DEVELOPMENT REVIEW COMMITTEE (DRC) COMMENT REPORT

PROJECT NAME: Gardenia Park

CASE NUMBER: R19007

REQUEST: Site Plan Level II Review: 46 Residential
Townhouse Units

Existing Stormwater Asset Map possibly affected by the Proposed Development

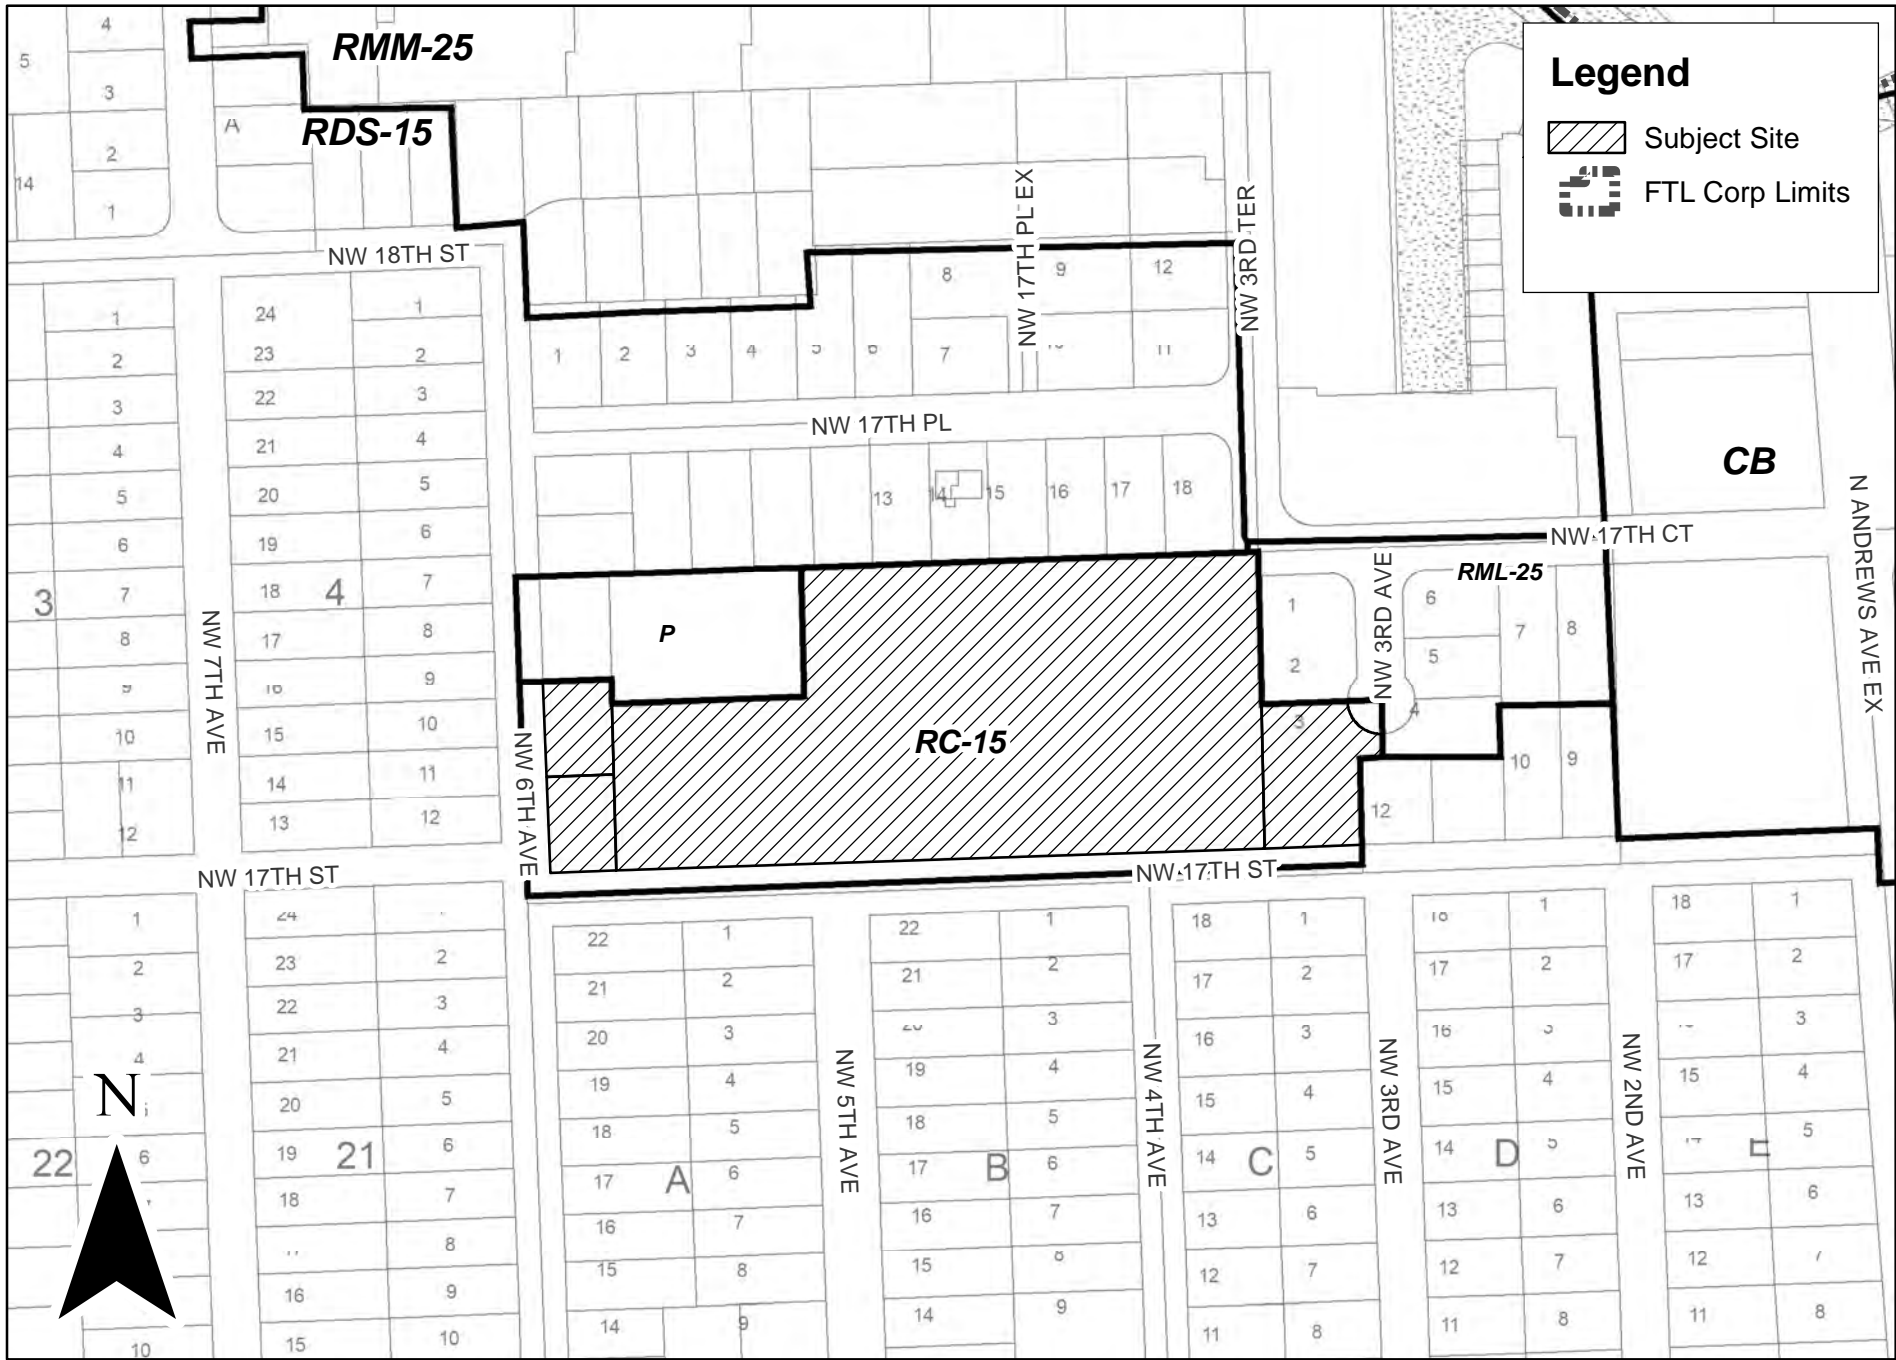
30. The City owns and maintains stormwater infrastructure adjacent to the proposed development as shown with green line work in the map provided at the end of this report.

- a) Contractor shall provide CCTV videotapes to City STW OPS of the existing stormwater system to the limits shown with green line work in the storm map provided at the end of this report in order to document the PRE and POST construction conditions of the City's storm system.
